SERVICE NEWS

VOLUME 32

APRIL, 1960

COMPLETE ADJUSTMENT PROCEDURE FOR CORVAIR CARBURETORS

Fig. 2—Type "H" Carburetor—Cross Section

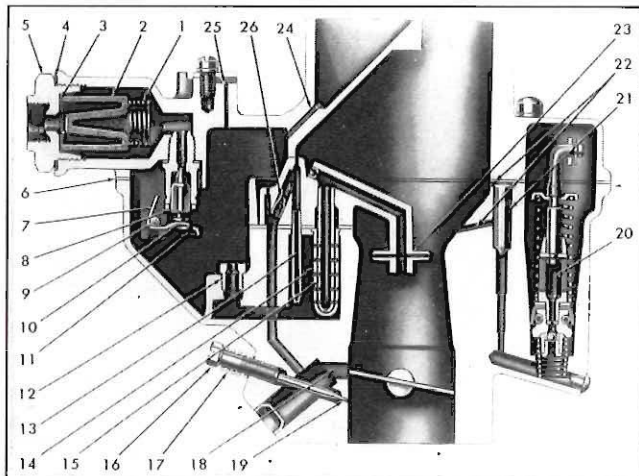
With the greater air flow it was necessary to change the amount of fuel being discharged into the throat of the carburetor. This was accomplished by increasing the size of the idle tube (13) .001" larger than the regular 3 speed transmission model carburetors. The restriction in the idle channel (26) has also been increased .001". When a vehicle is to be used for extended high speed operation, the main metering jet (12) should be replaced with one that is .001" larger (fig. 2).

Fig. 5—Ignition Timing Marks

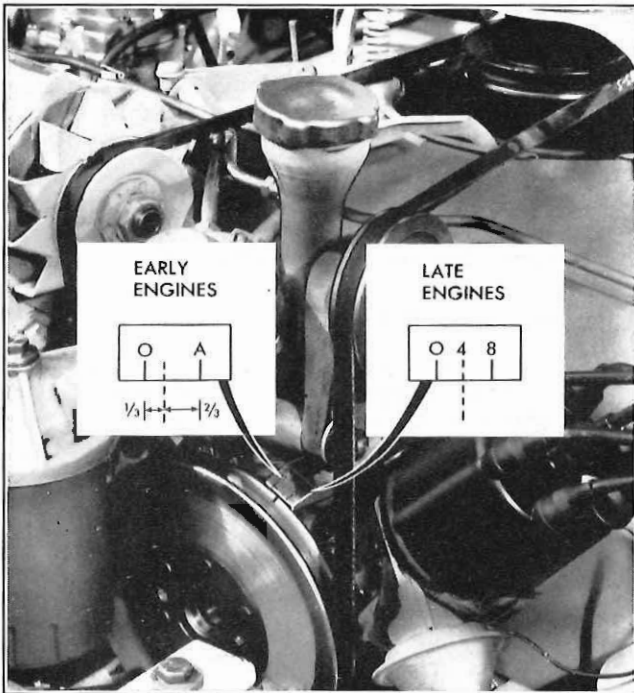
19. When setting the ignition timing, check the color of the oiler. Set distributors with cadmium or bright colored oilers to 4° BTDC. Distributors with the

oilier painted black or copper should have the ignition timing set to 16° BTDC.

If setting the spark advance to 16° BTDC causes pre-ignition or detonation, reset the spark advance to 14° BTDC.

Fig. 7—Tightening Pinion Bearing Adjusting Sleeve with J-972

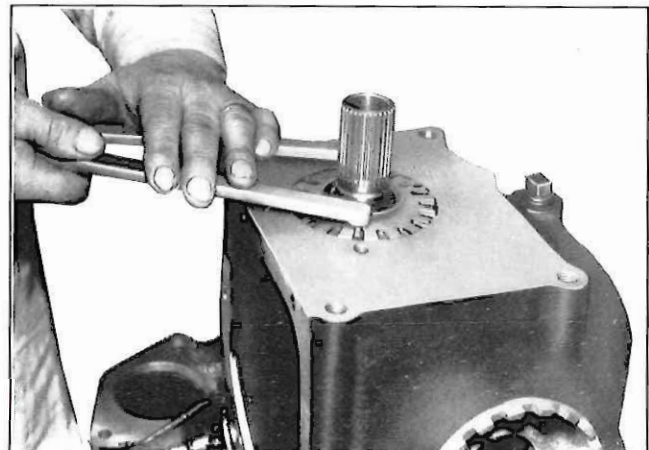
A revised procedure for preloading the drive pinion bearings has been developed and supersedes information in Step 4, page 6C-20 of the 1960 Corvair Shop Manual. The procedure for adjusting the differential side bearings remains the same.

1. Adjust differential side bearings according to Steps 1, 2 and 3, page 6C-20, Corvair Shop Manual.
4. Tighten pinion bearing adjusting sleeve with tool No. J-972 (fig. 7) to just remove pinion bearing end play, then back off the adjusting sleeve 1/4 turn.
5. Measure the turning torque at the drive pinion using J-8362 adapter and inch-pound torque wrench J-5853 (fig. 8).

Fig. 9—Ignition Timing and Centrifugal Advance Curve

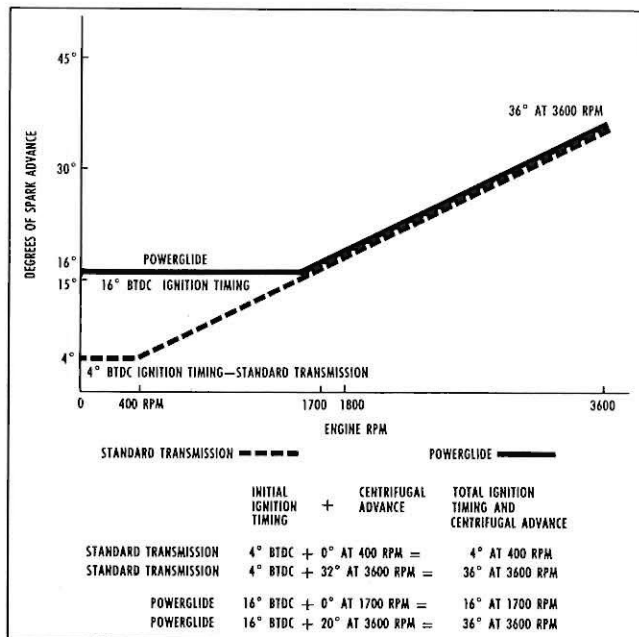
Recent changes have been made in the construction and application of the Corvair distributor identification marks, centrifugal advance, vacuum advance, and ignition timing specifications. The new centrifugal advance and ignition timing specification of 16° BTDC for the Powerglide and High Performance units give a better start up and break away feel during the first mile of driving after the choke comes off.

The ignition timing setting for late production Powerglide models and high performance models is 16° BTDC. This means the spark advance at idle is 16°. For Powerglide models at 1700 RPM, the centrifugal advance mechanism rotates the breaker cam in the direction of rotation, causing the amount of spark advance to increase. At 3600 rpm the centrifugal advance is 20° which gives a total spark advance of 36°. Fig. 9 illustrates the total degrees of spark advance for the initial ignition timing and the centrifugal advance for all models except the Turbo-Air Special.

A modification package is available for early production Powerglide models to change the ignition timing setting from 4° BTDC to 16° BTDC. After the distributor has been modified, the oiler cap should be painted black. A timing tab should be installed to serve as a guide for setting the ignition timing at 16° BTDC.

When setting the ignition timing, check the color of the oiler. Set distributors with cadmium or zinc colored oilers to 4° BTDC. Distributors with the oiler painted black or copper should have the ignition timing set to 16° BTDC.

If setting the spark advance to 16° BTDC causes pre-ignition or detonation, reset the spark advance to 14° BTDC.

Fig. 11—Reforming Control Cable Support

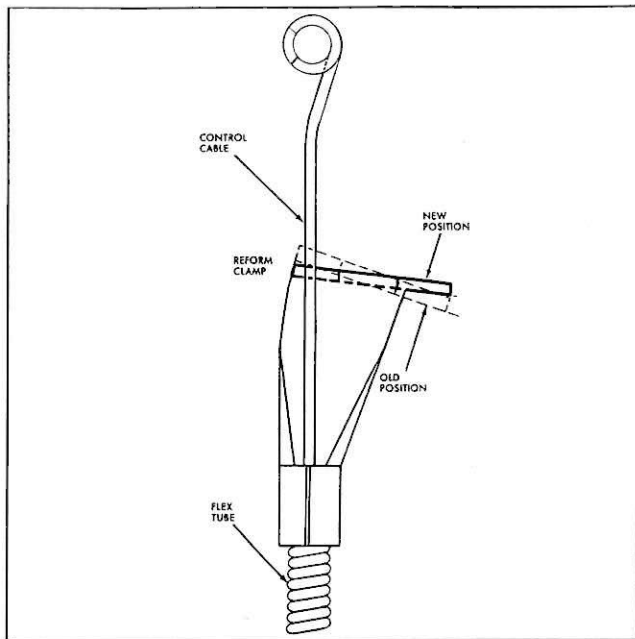
5. If the control cable is binding, remove screws holding switch on steering post and screw holding flexible tube clamp at the top of the mast jacket.
6. Pull cable and tube assembly up and reform clamp according to (fig. 11).

NOTE: Reforming the cable tube support provides more clearance for the free entry of the cable into the tube.

Fig. 12—Repositioning Clips 180°

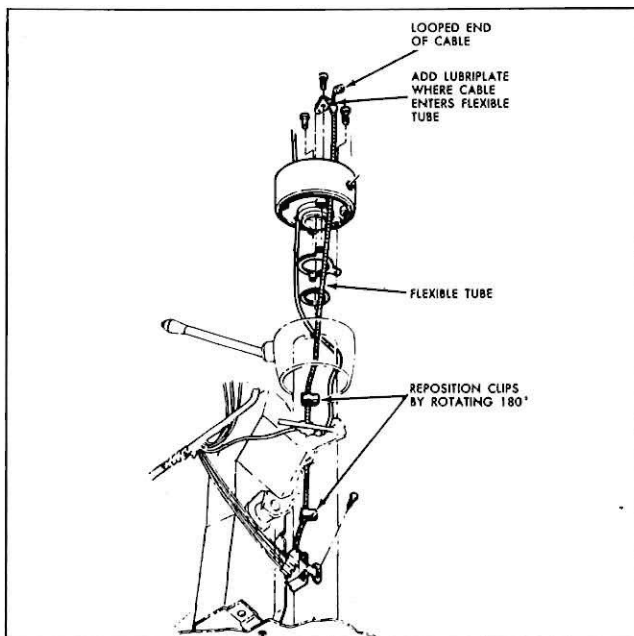
7. Add Lubriplate or equivalent to cable at point of entry into tube.
8. Remove and discard retainer holding looped end of cable onto the crank rod.
9. Remove two (2) clips holding cable on steering post, rotate clips 180°, then reinstall the clamps (fig. 12).
10. Disconnect the control cable from the switch (fig. 13).
